Reference: **ACCESS AUDIT CONSULTANCY DEVELOPMENT APPLICATION STAGE  
26 ELIZABETH ST, LIVERPOOL NSW 2170**

### HOTEL, RESIDENTIAL AND COMMERCIAL DEVELOPMENT 26 ELIZABETH STREET LIVERPOOL, NSW

Document Type: **Access Report**

Report Number: **IAC-818**

Figure 21 – Extract from Ground Floor Plan. Fire stairs marked in dark green.

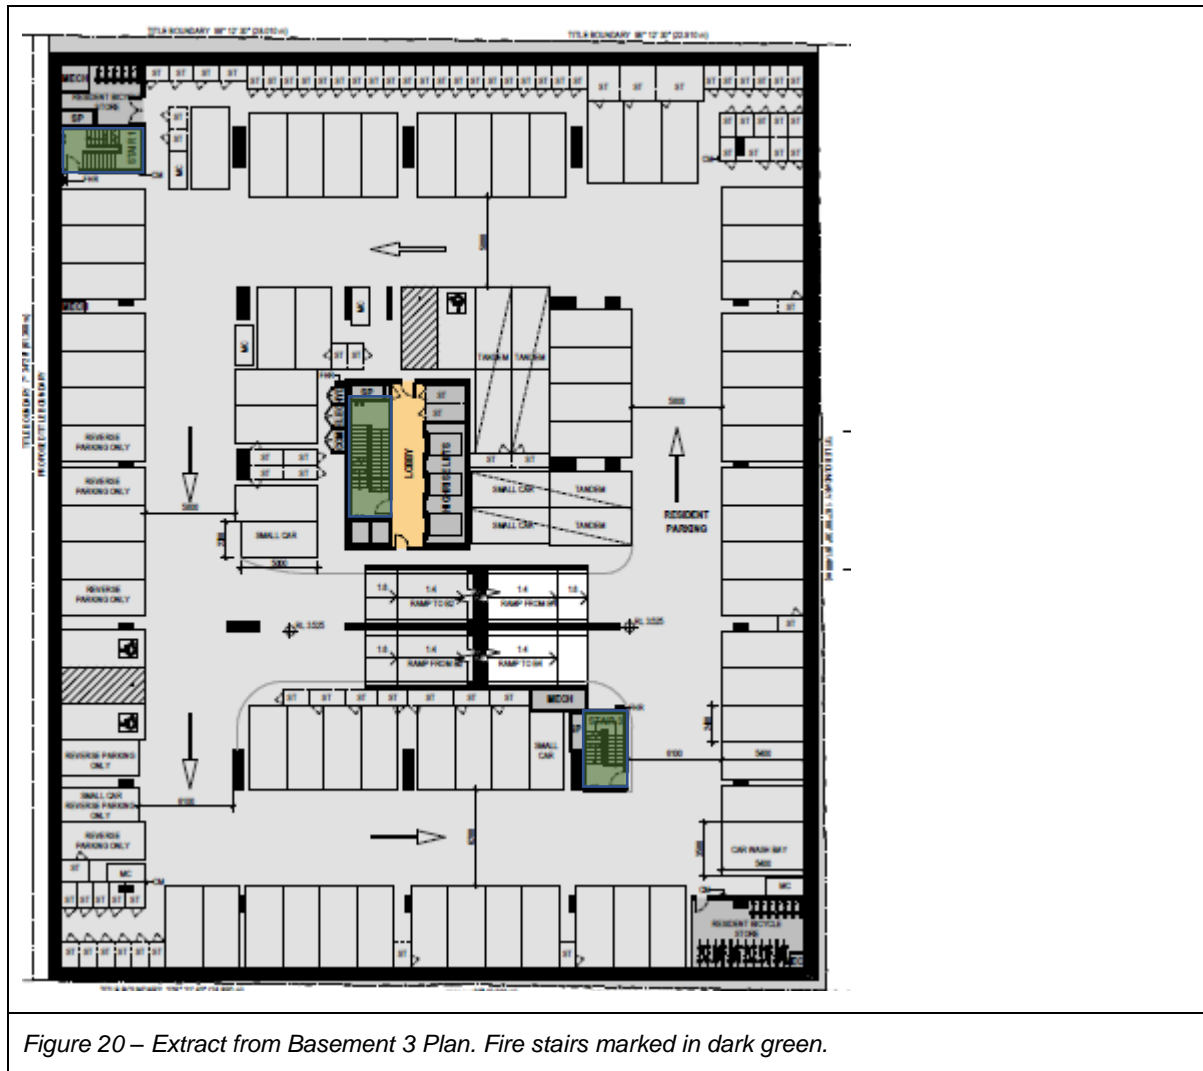
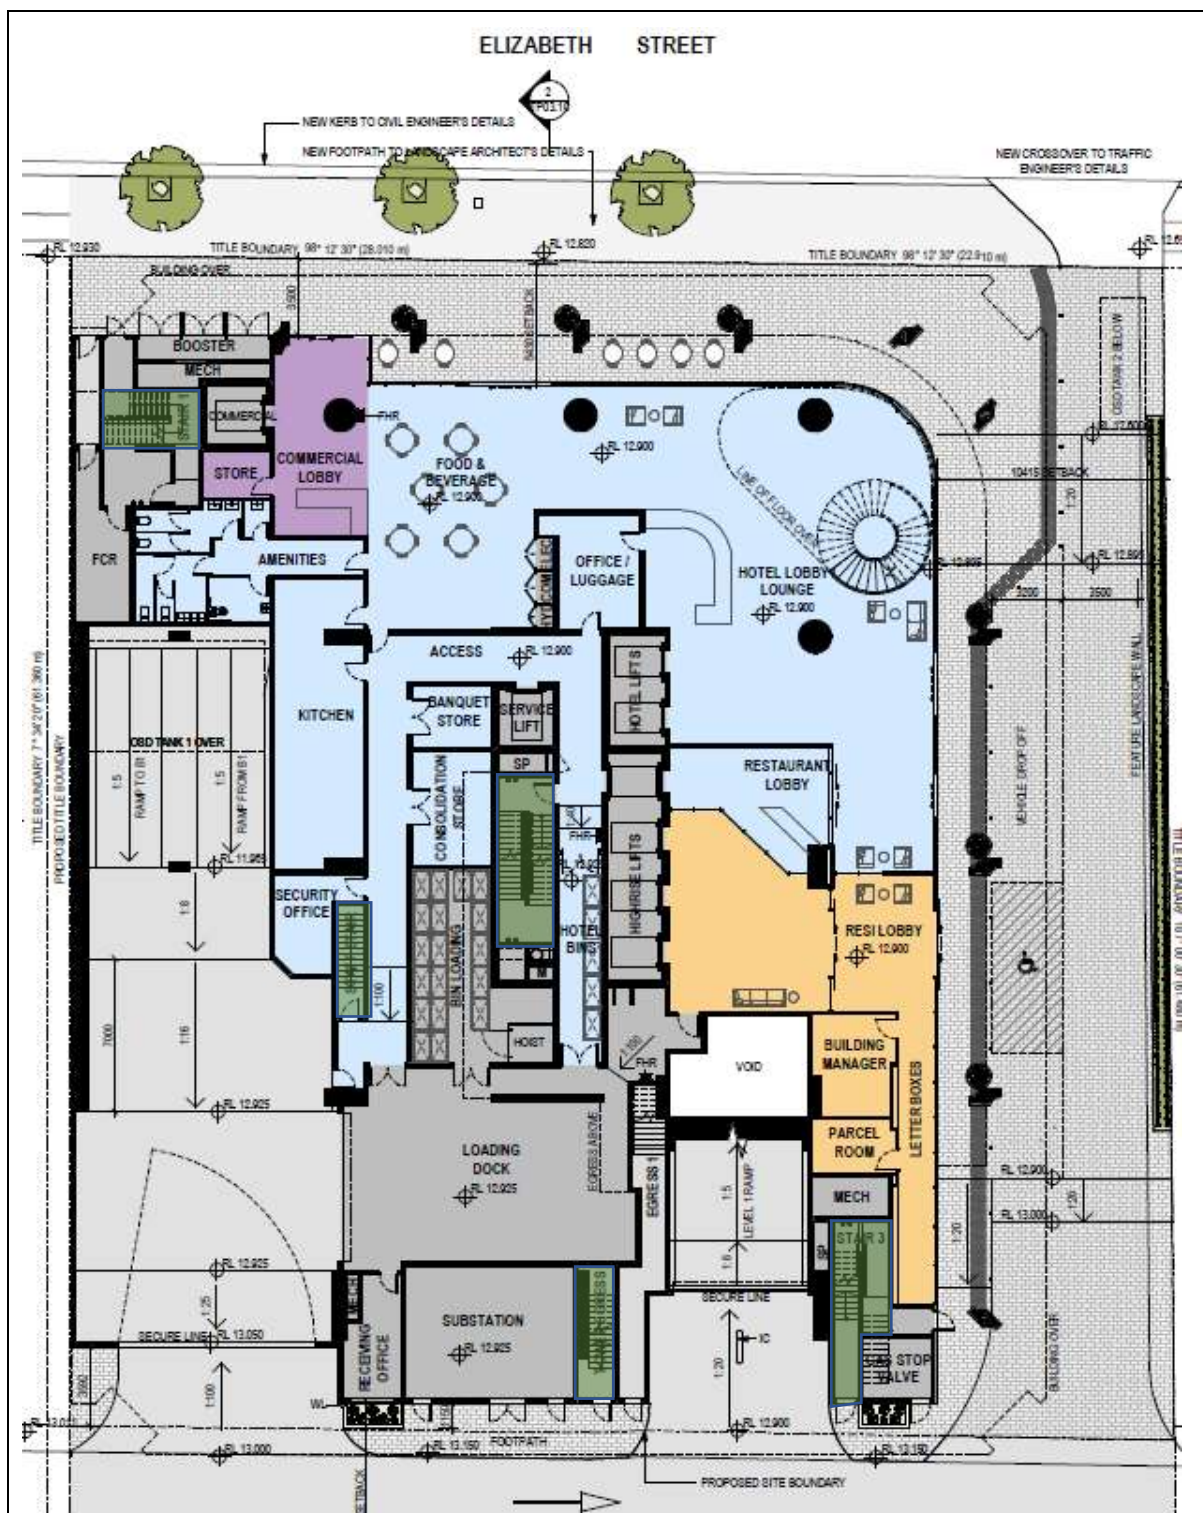
Several sets of fire stairs proposed. Their locations are highlighted on the plan extract below.

The detailing of fire stairs will need to satisfy the requirements of Clauses 11.1 (f) & (g) of AS1428.1:2009.

A detailed plan for fire emergency exit is required, including the provision of stair sleds or the like.

Figure 47 – Extract from Level 9 Floor Plan

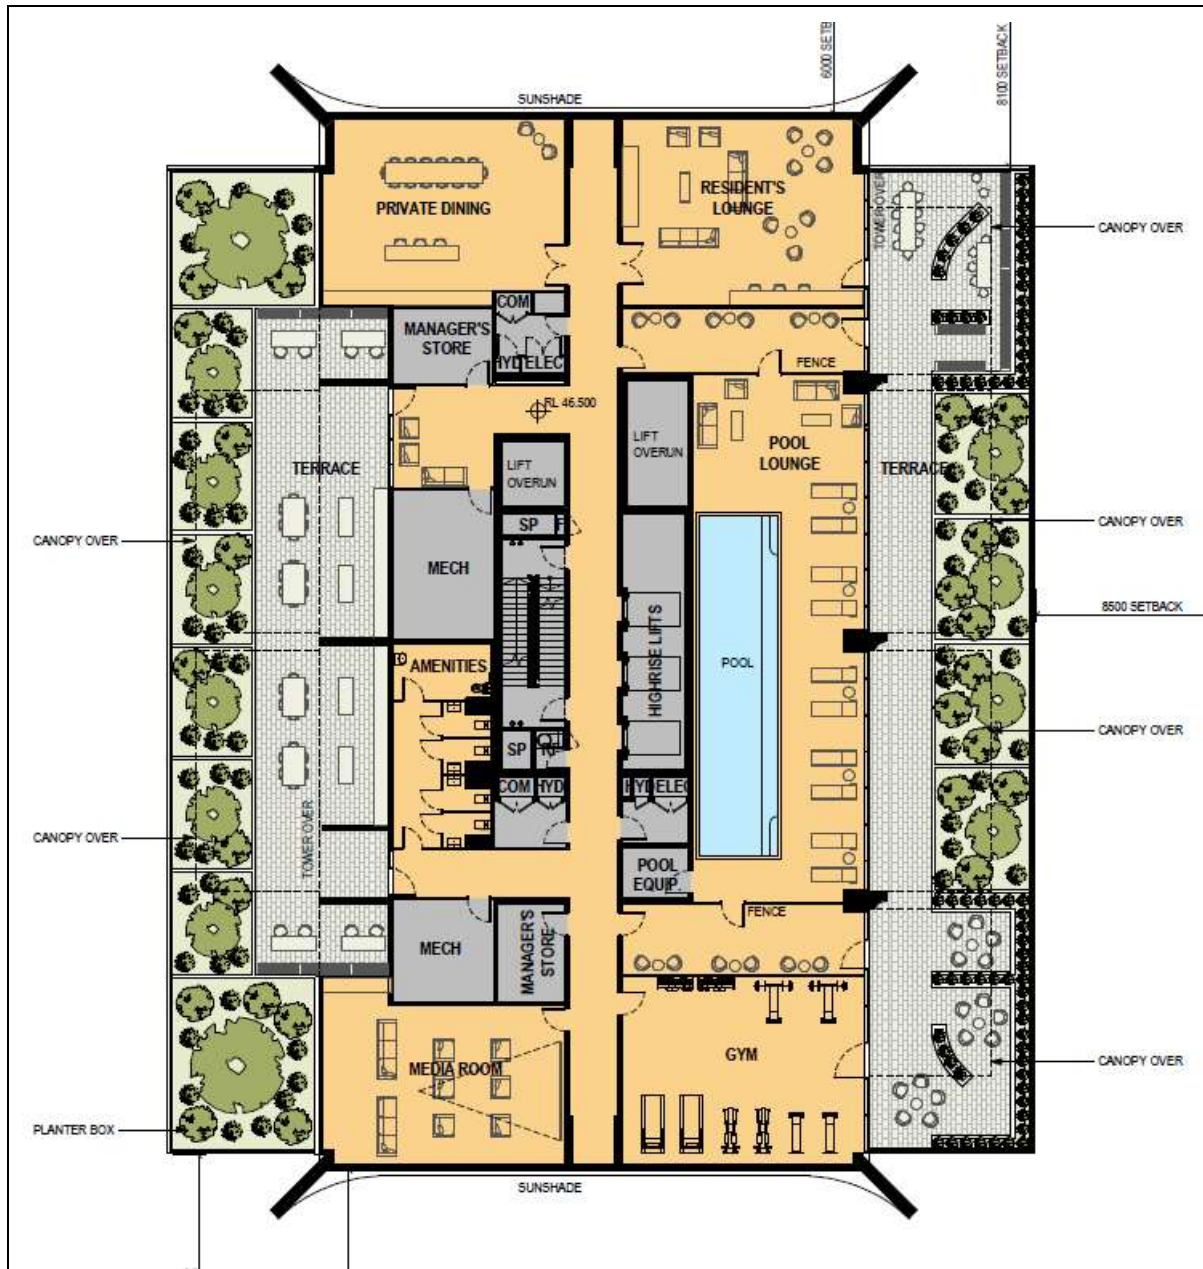
**Compliance:** As the pool perimeter is less than 40m there is no requirement to provide any accessible entry to the swimming pool itself.
